Access Compliance Report Public Rights-of-Way (Pedestrian Signals)

Main Street: **ORANGE_PARK_BLV** Cross Street: **ORANGE_PARK_BLV** Location: **SW**

ADA ID: **SGRK211222133137** Signal Type: **One Push Button-Non APS** Overall Compliance: **No** Severity Scores: **BTN 1: 10** **BTN 2: N/A** **No BTN: N/A**

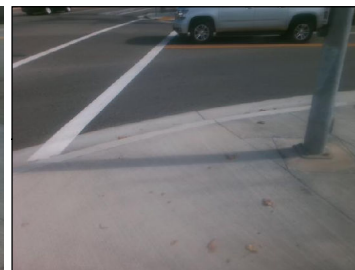
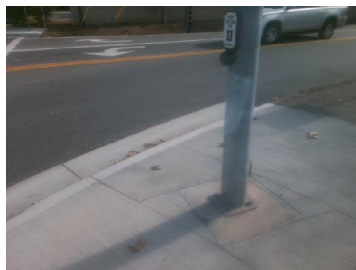
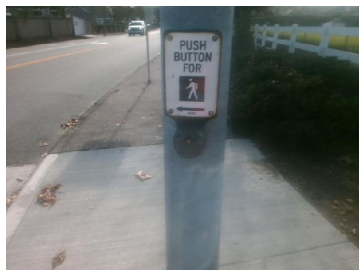
OC Std/PROW: MUTCD 4e.08, DMS-11132, R104.2, R209.1

Possible Solutions: Replace Signal Push Button With APS Button. Remove & Relocate Sign.
